BURNETT RIVER FLOODPLAIN ACTION PLAN

COMMUNITY REFERENCE GROUP MEETING

MINUTES

XS 6

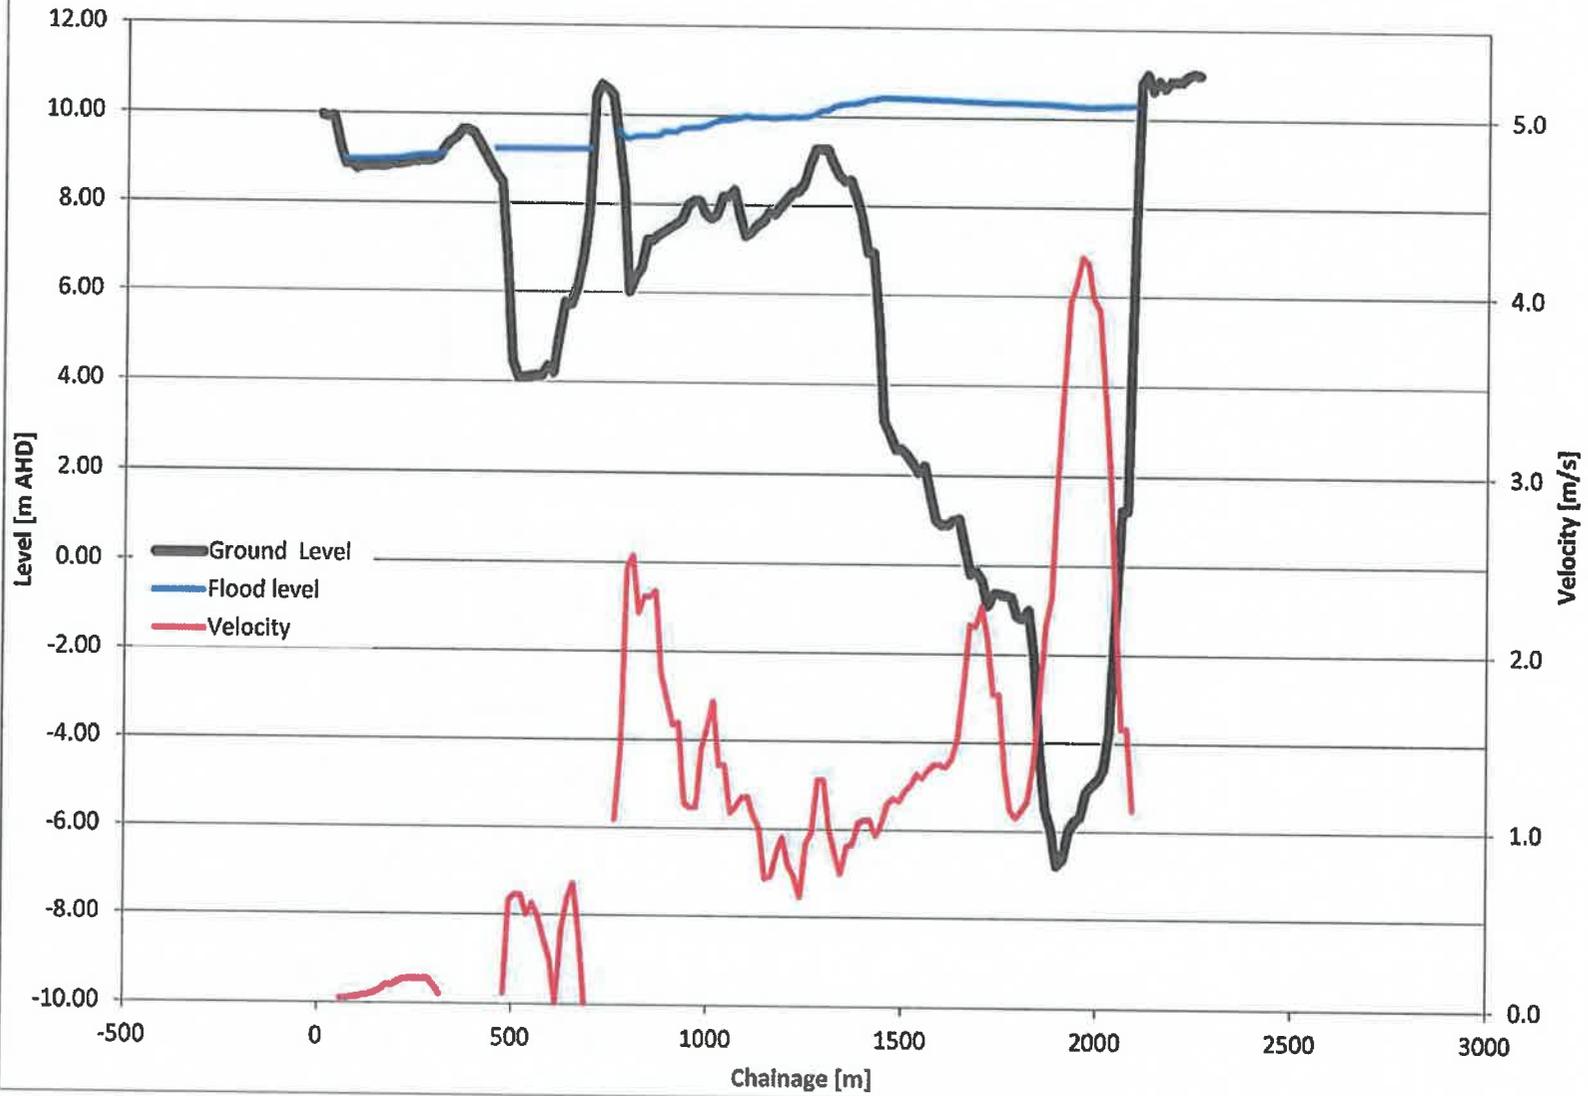
Rob Marshman referred to the flow velocities in GHD's email dated 31 October 2013 (copy attached to these minutes) and stated that many of these recorded velocities seem to be less than what was observed at the time of the 2013 Flood. Dan Copelin explained that the surface velocity is higher than the average velocity taken in a cross section and that whilst some of those surface velocities were excessively high; such velocities will not be shown in GHD's results which only reflect averaged velocities.

ROUGH SKETCH - RIVER SUCH AS BURNETT IN ADVANCED STAGES OF MODIFICATION. - EXAMPLE, SKETCH ONLY.

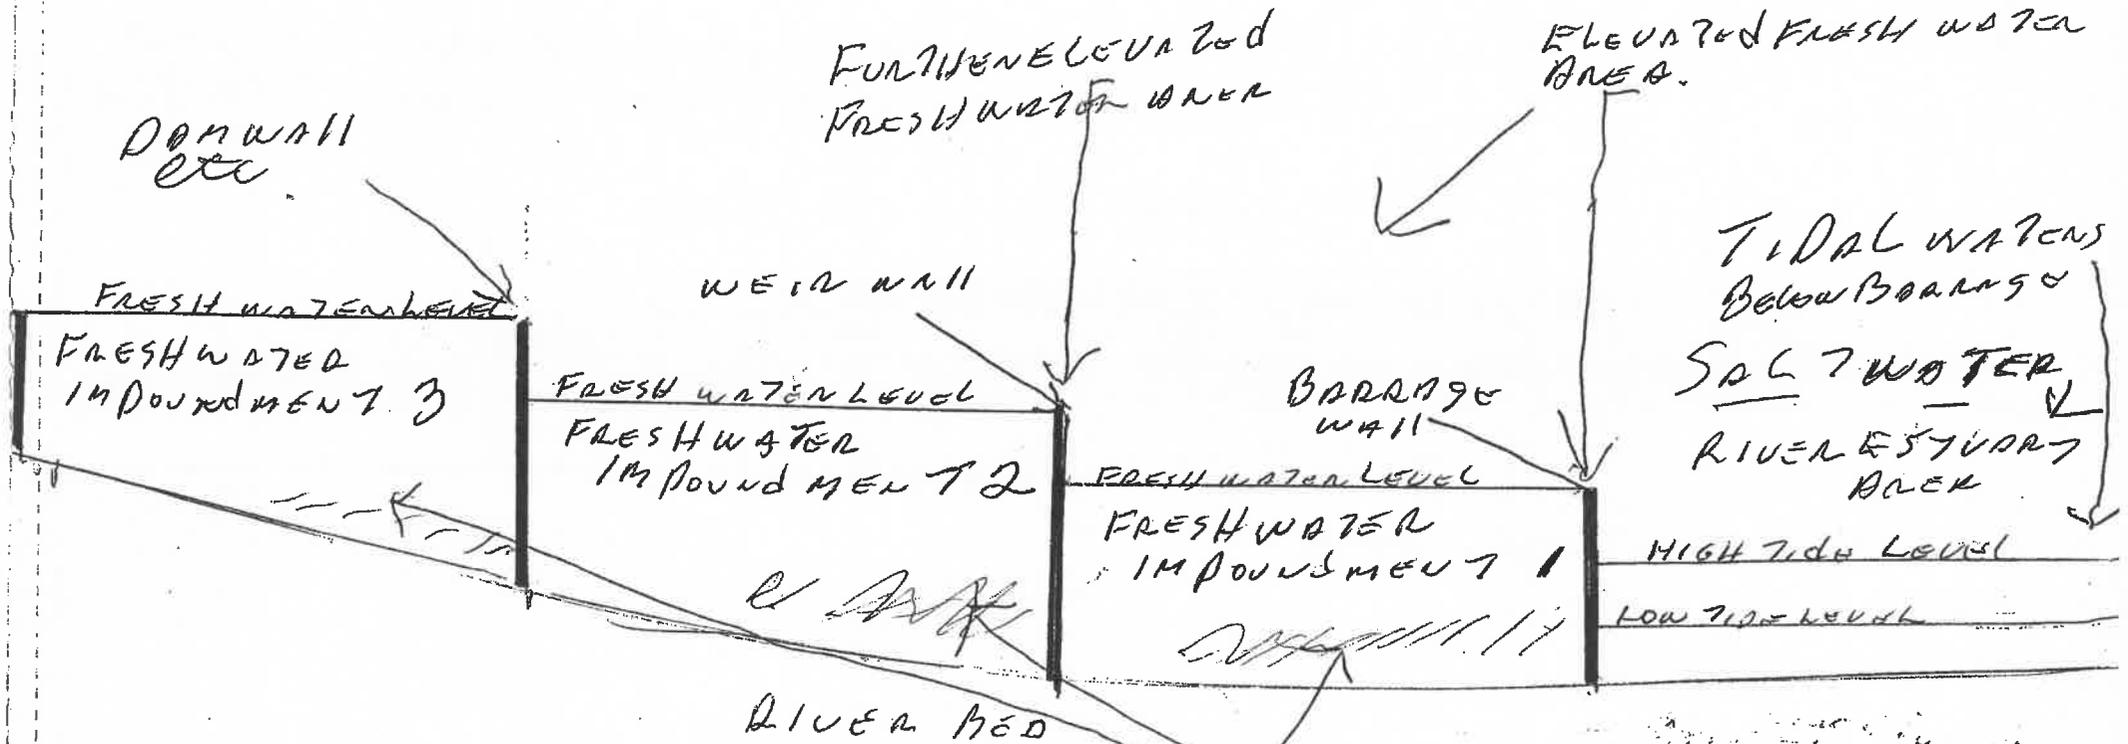
I contend this elevated river height cannot lessen during flood periods, and must in fact increase the water levels, compared to a pristine system.

* OF ITSELF, THE MODIFIED SYSTEM CONTAINS DAM, WEIR AND BARRAGE WALLS WHICH ARE ELEVATED BY THEIR ENGINEERING DESIGNS. THIS MUST BE SO IN ORDER TO CATCH AND STORE INCREASED WATER LEVELS.
